Access Compliance Report Public Rights-of-Way (Curb Ramps)

Main Street: FLINTRIDGE_AVE Cross Street: STRATHMORE Location: S

ADA ID: RPAT211103155537 Ramp Type:Type 1 - Perpendicular Diagonal Initial Pass/Fail: Fail Overall Compliance: No Severity Score: 2

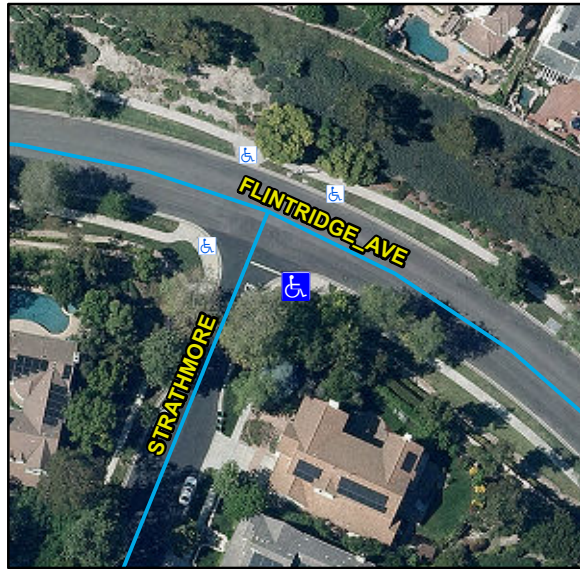
Compliance	Description	Data	Compliance	Description	Data
N/A	Ramp Length (in)	48	N/A	Flare Type LT	
Yes	Ramp Width (in)	55			N/A
Yes	Ramp Run Slope (%)	7.1	N/A	Flare Slope LT (%)	N/A
No	Ramp Cross Slope (%)	2.5	N/A	Flare Traversable LT	N/A
N/A	Landing Present	N/A	N/A	Flare Type RT	
N/A	Landing Length (in)	N/A			N/A
N/A	Landing Width (in)	N/A	N/A	Flare Slope RT (%)	N/A
N/A	Landing Run Slope (%)	N/A	N/A	Flare Traversable RT	N/A
N/A	Landing Cross Slope (%)	N/A	N/A	DWS Provided	N/A
N/A	Landing Movement Obstructed?	N/A	N/A	DWS Contrast	N/A
	Landing Movement Type	N/A	N/A	DWS Length (in)	N/A
N/A	Landing Shared	N/A	N/A	DWS Full Width	N/A
N/A	Clear Space	Yes	N/A	DWS Offset Left (in)	N/A
N/A	Clear Space To Crosswalk (in)	N/A	N/A	DWS Offset Right (in)	N/A
N/A	Marked Crosswalk 1	No	N/A	Marked Crosswalk 2	No
	Crossing 1 Direction	NE		Crossing 2 Direction	NW
	Marked Crosswalk 1 Width (in)	N/A		Marked Crosswalk 2 Width (in)	N/A

Remove & Replace Curb Ramp With Two New Directional Ramps or Equivalent.
